TOWN OF MILFORD, NH
OFFICE OF COMMUNITY DEVELOPMENT

STAFF MEMORANDUM

Subject: **Ronald and Loreen Racicot, 21 Old Wilton Road, Tax Map 14 Lot 10.** Public Hearing for a major site plan application to construct a 2,400 sf. warehouse building and associated site improvements within the Industrial District. *(Continued from March 27, 2018)*

SITE LAYOUT PLAN
INDUSTRIAL DEVELOPMENT
TAX MAP PARCEL 14-10 - 21 OLD WILTON ROAD
MILFORD, NEW HAMPSHIRE
PREPARED FOR AND LAND OF:
RONALD L. & LOREEN M. RACICOT
70 PUTNAM HILL ROAD, LYNDENBOROUGH, NH 03082-6134.

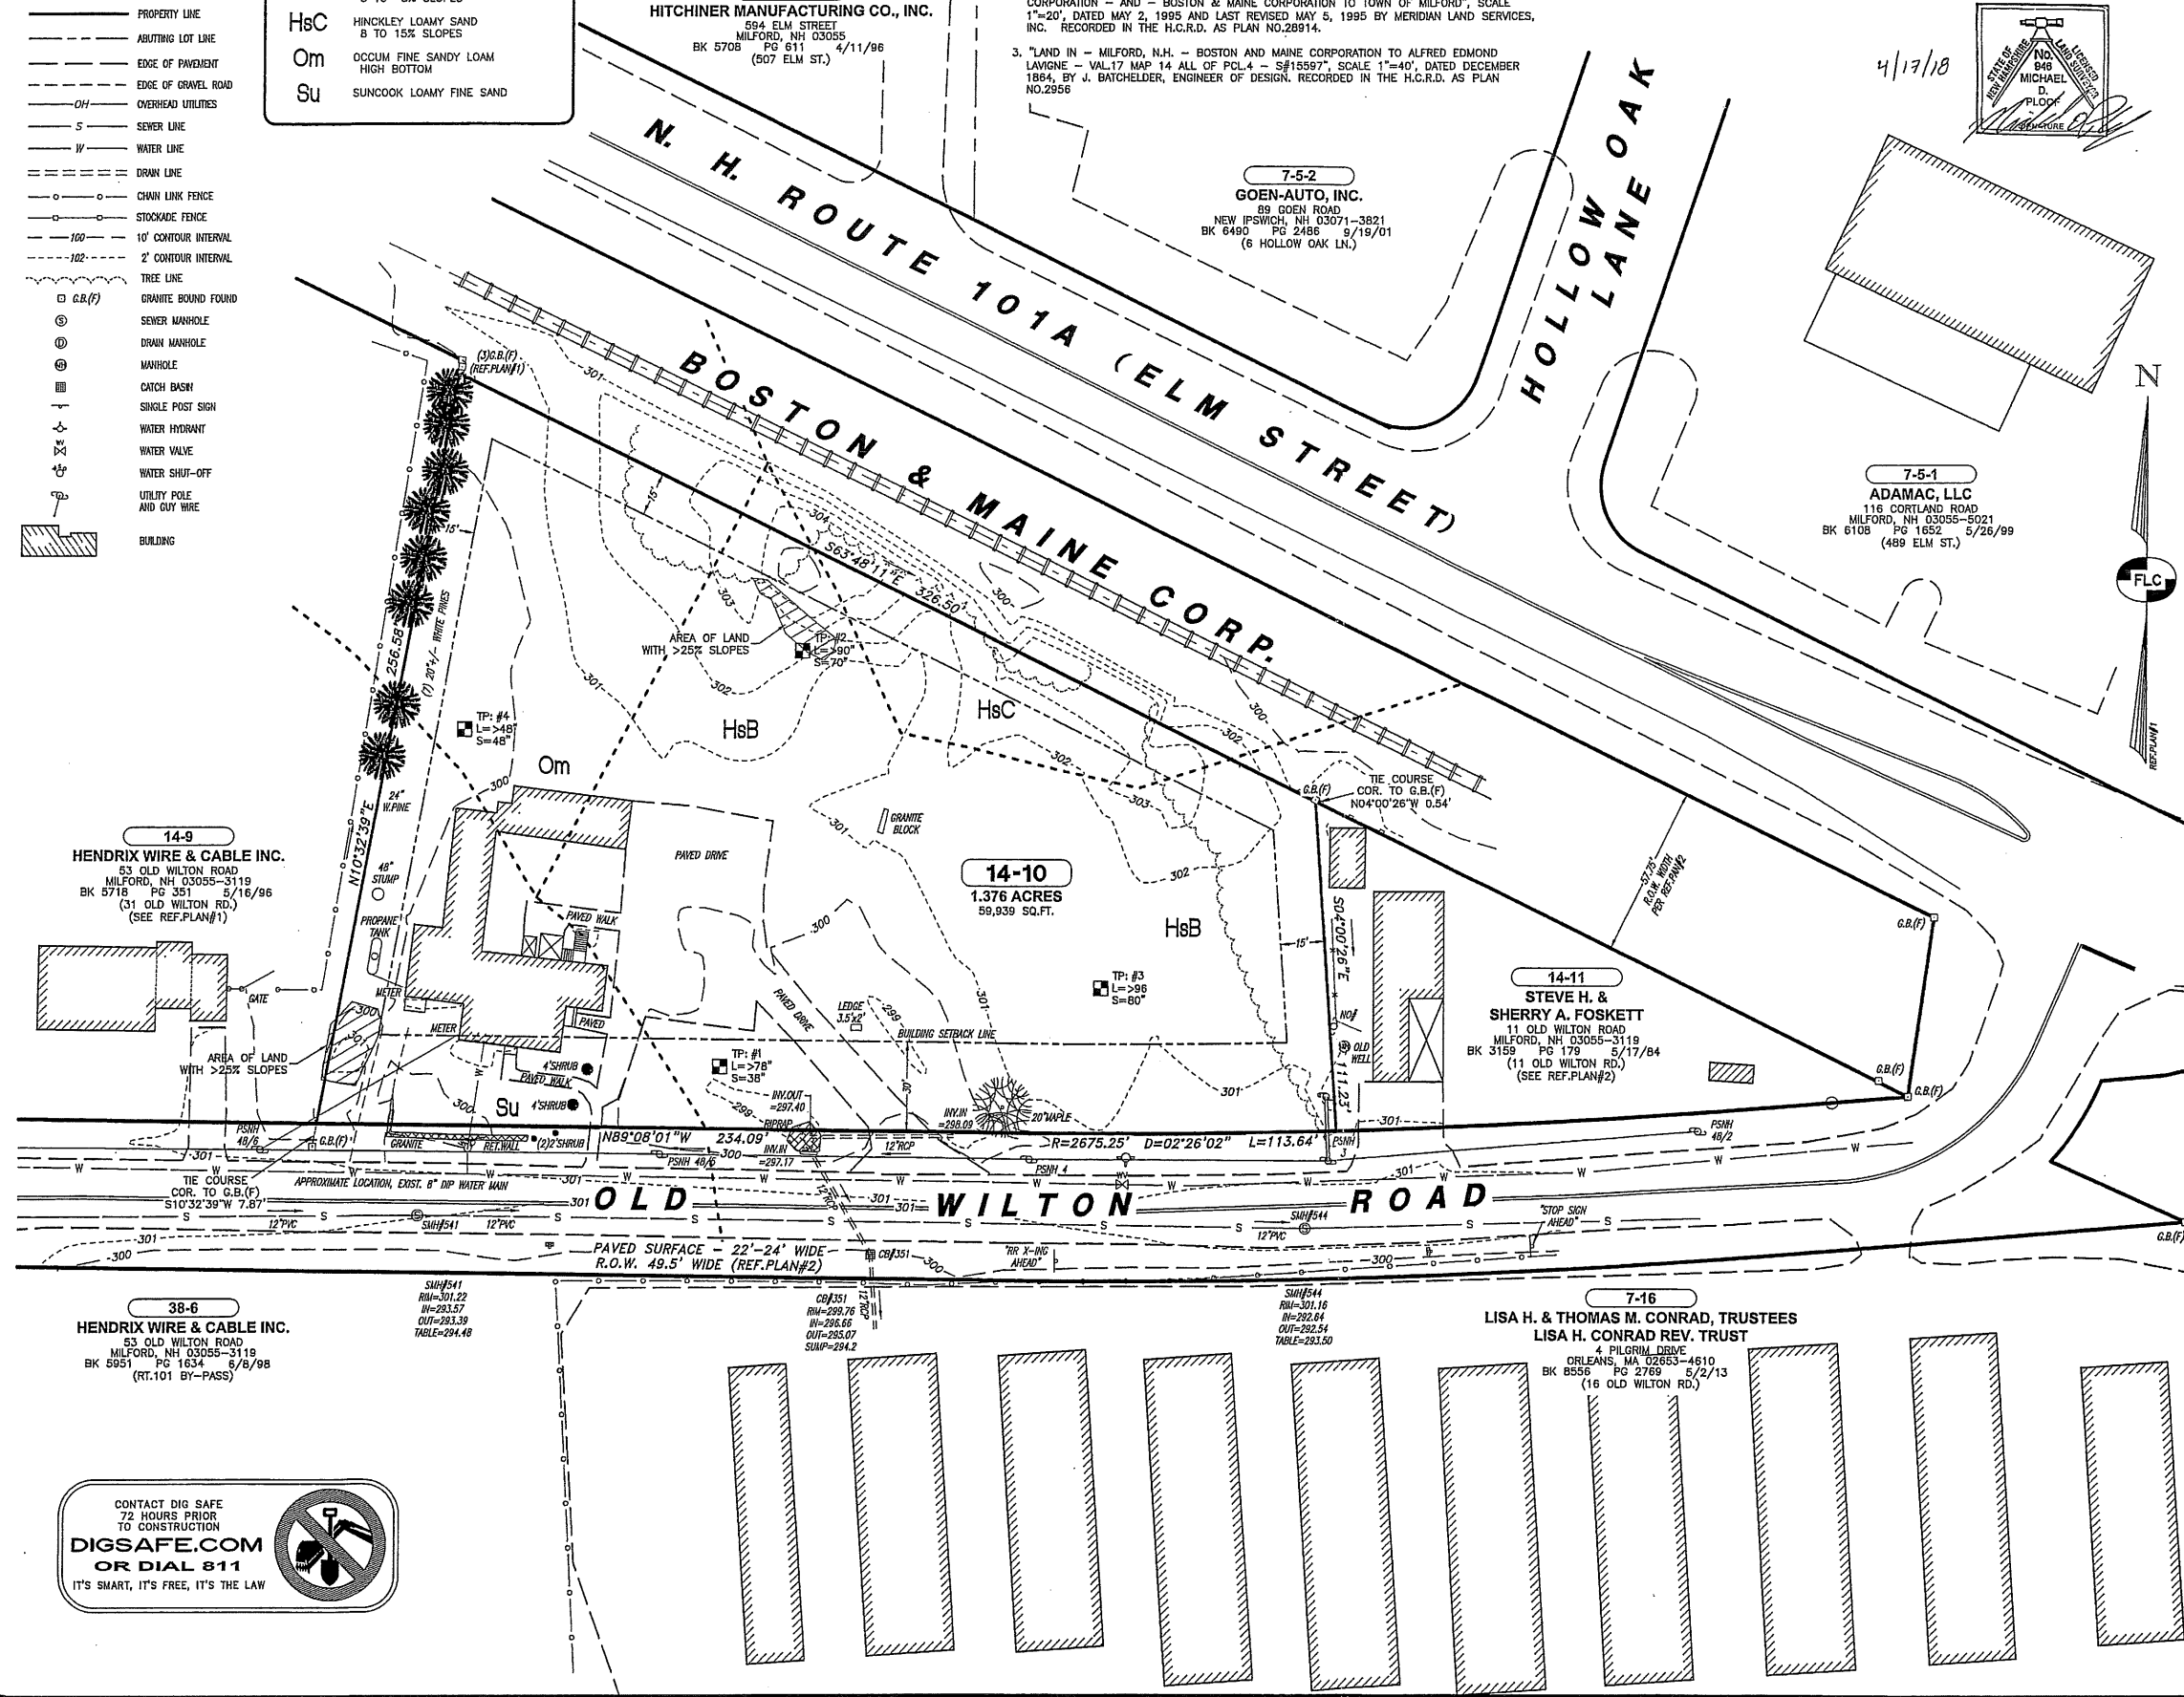
1. Sheet 2. Please provide building elevations. The applicant is strongly encouraged to review the Zoning Ordinance, Section 6.07 West Elm Street Overlay District for applicable design standards relating to building orientation, massing, access management, architectural features, etc. when

submitting the final building elevations.

Partially Addressed. The applicant submitted revised elevations of the proposed warehouse building. See attached building elevations. The Board will need to determine if the structure meets the intent of the West Elm Street Overlay District. The applicant submitted a revised landscape design that meets the intent of the Development Regulations and West Elm Street Overlay District. The landscape plan provides sufficient visual mitigation of the industrial building along Elm Street and the surrounding residences.

SITE LANDSCAPING PLAN
INDUSTRIAL DEVELOPMENT
TAX MAP PARCEL 14-10 - 21 OLD WILTON ROAD
MILFORD, NEW HAMPSHIRE
PREPARED FOR AND LAND OF:
RONALD L. & LOREEN M. RACICOT
70 PUTNUM HILL ROAD, LYNDENBOROUGH, NH 03082-8134.

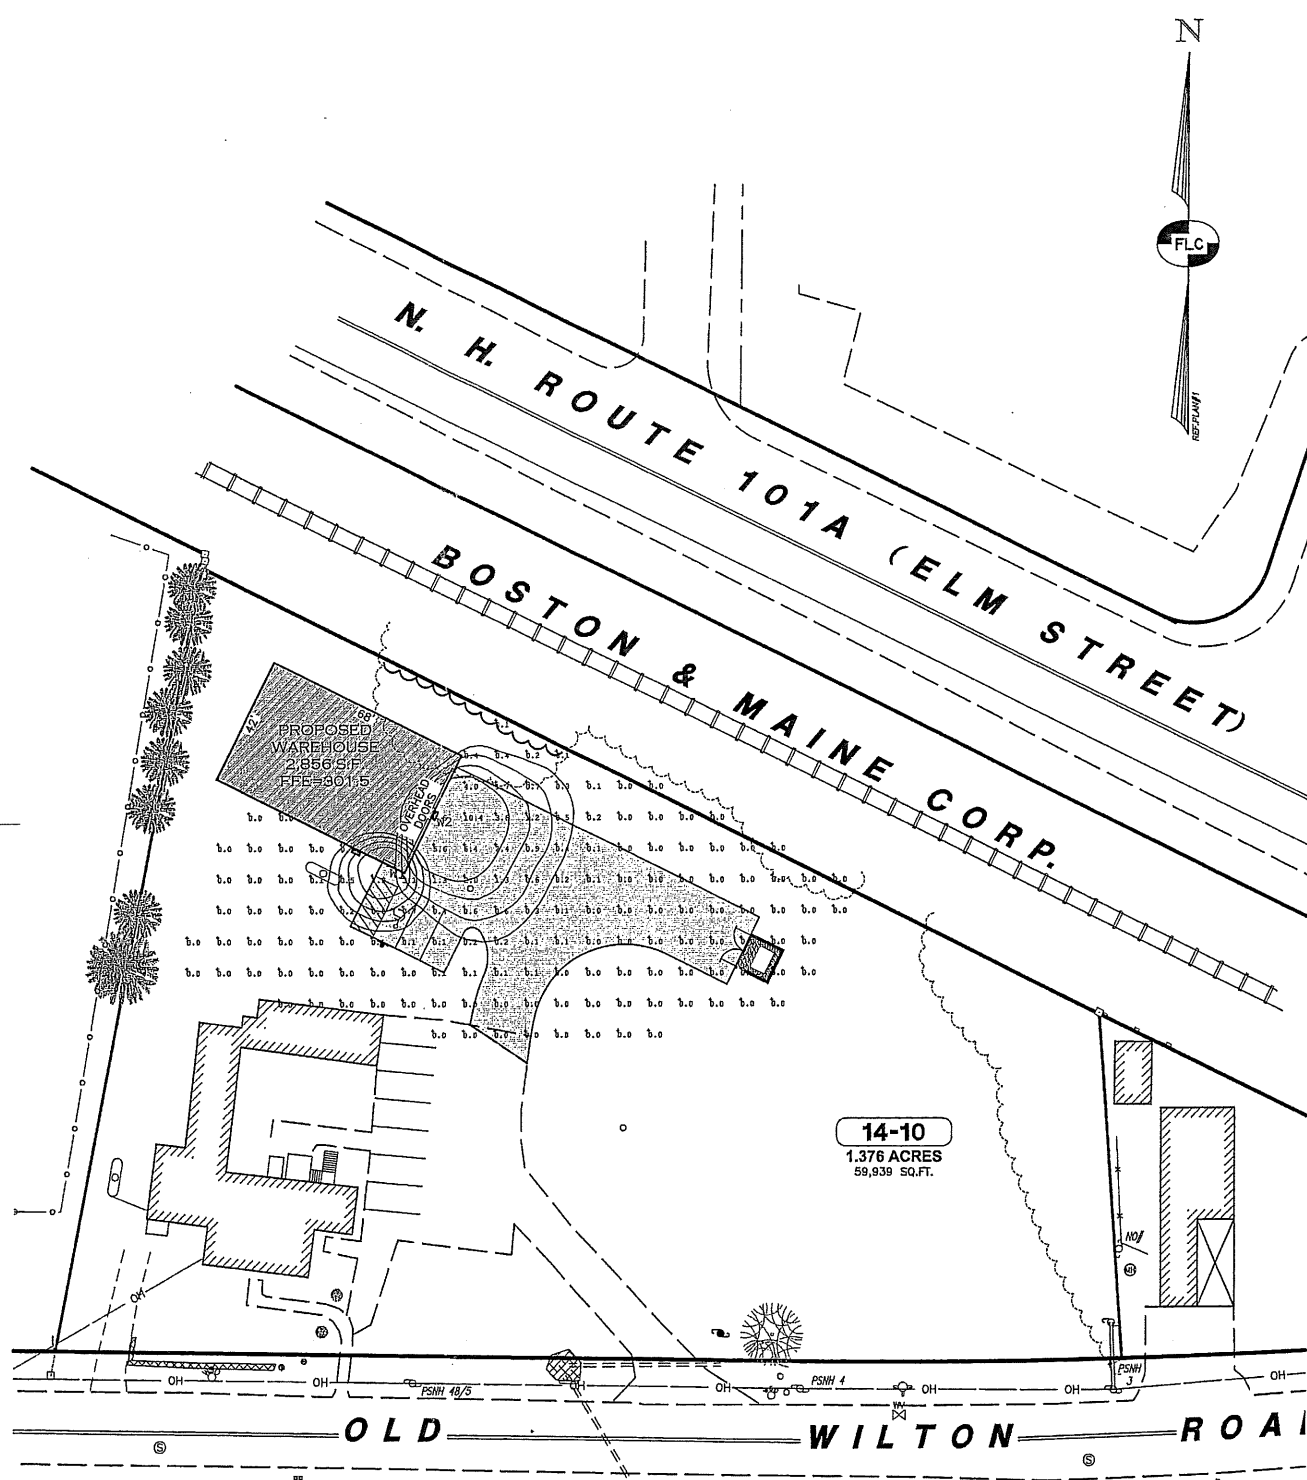
2. General Comment. The submitted application and plan included a partial landscape design in accordance with the Development Regulations, Section 6.08 Landscaping Standards and the Zoning Ordinance, Section 6.07 West Elm Street Gateway District (and associated West Elm Street Gateway District Design Guidelines).
 - a. Please revise the plans to include a landscape design in compliance with the Development Regulations and or submit waiver (with narrative) seeking relief from the said Section.
 - b. Consideration must be given to the abutting residential properties to the South and East when designing a landscape plan and providing the required visual buffer.
 - c. Screening along the building the property frontage on Elm Street will be required.

Partially Addressed. The applicant submitted a revised landscape design that meets the intent of the Development Regulations and West Elm Street Overlay District. The landscape plan provides sufficient visual mitigation of the industrial building along Elm Street and the surrounding residences. However, the site plan will need to be revised to include details and notes related to the installation and maintenance of the plantings.
